## SERVICE BULLETIN

### Design Change of the Idler Gear Case and Idler Gear Bolt

Subject models: NA6J, NB6J, NC6J, NE8J, NJ8J and NV8J  
 Subject engines: J08E-VC, VB (EPA10), J05D-TF, J08E-TV/TW, J05D-TA/TB

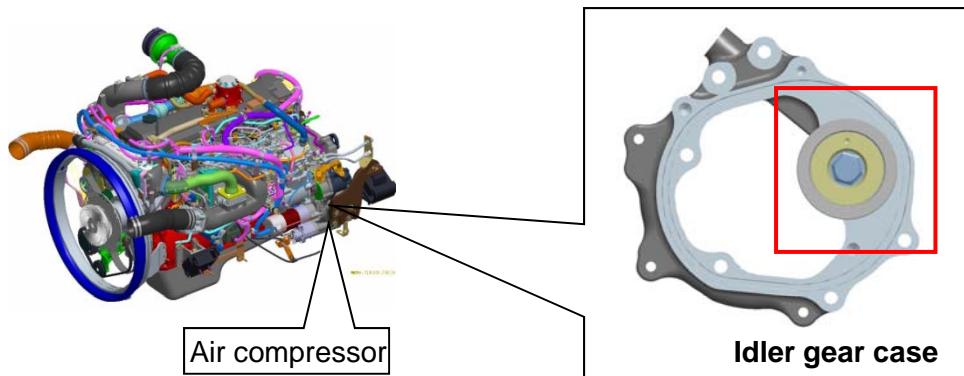
Abnormal load such as a stuck supply pump was applied to gear train then causing the bolt to loosen. Therefore, an enhancement to the case and bolt were carried out.

The idler gear case and bolt were changed to increase the robustness for the abnormal load. The details are as follows.

Contents	Original	Enhancement
<b>Idler Gear Case</b> Cross section of red square are as above		
Bolt class	10T	11T
Bolt length	50mm	58mm
Tightening torque	108Nm	155Nm

J08E-VC,VB (11-13MY)	J05D-TF, J08E-TV/TW (08-10MY)	J05D-TA/TB (05 -07MY)
Bolt: SZ91024489	Bolt: SZ91024489	Bolt: SZ91024489
Case: 13607E0052	Case: 13607E0011	Case: 13607E0021
